**8. COA-053434-2019**

Commission of  
Architectural Review

STAFF REPORT

**Renovate an existing front porch.**

Figure 1. 3202 Monument Ave, front walkway.

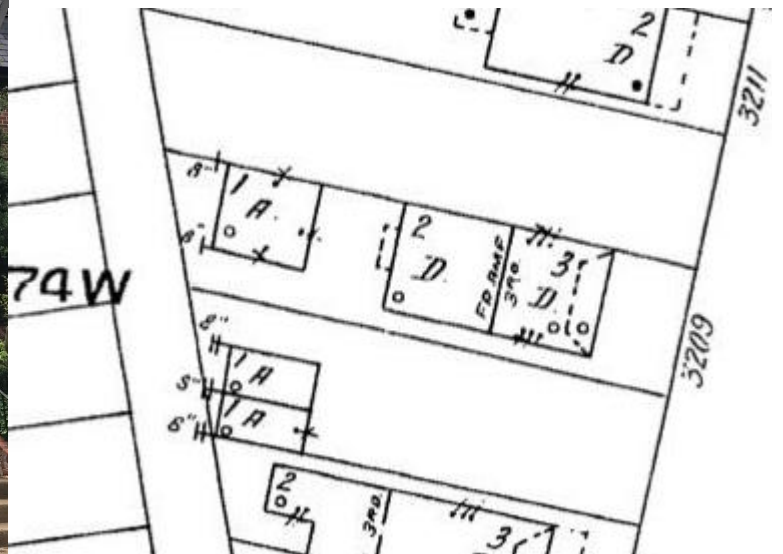
The 3200 block of Monument Avenue contains many examples of paved walkways and front patios. Many homes have been altered with the

addition of new materials, however there are several examples of brick, concrete and red tile. The existing materials are common for the district as well as the period of construction, and there are several surrounding examples of the same materials. Though it appears that the tile has been repaired in the past, the existing materials are likely historic.
